A518 & A618 Chrysler Automatic Transmission

PRODUCT BULLETIN

Driveshaft Yoke Does Not Fit the Output Shaft

OUTPUT SHAFT DIFFERENCES

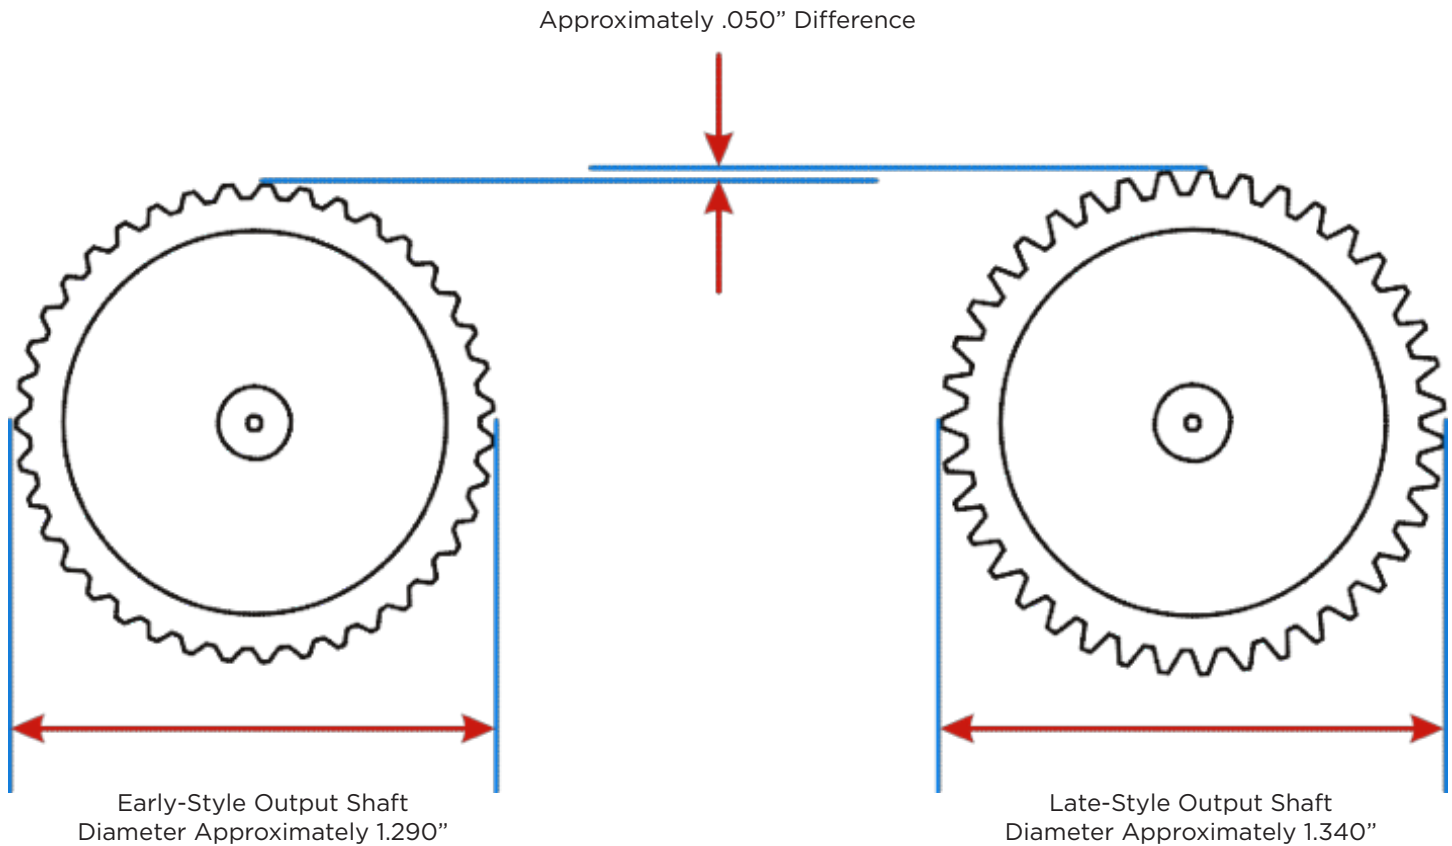
A late-style output shaft will not fit when used in conjunction with an early-style driveshaft yoke. The reason being the Chrysler Corporation changed the outside diameter of the output shaft in the spline area, which increased the contact area of the yoke splines for improved durability. The yoke changed, as well, to accommodate the output shaft change.

During the remanufacturing process, the output shaft has been machined to fit both the early- and late-style driveshaft yoke, eliminating the need to purchase and install a late-style driveshaft yoke.
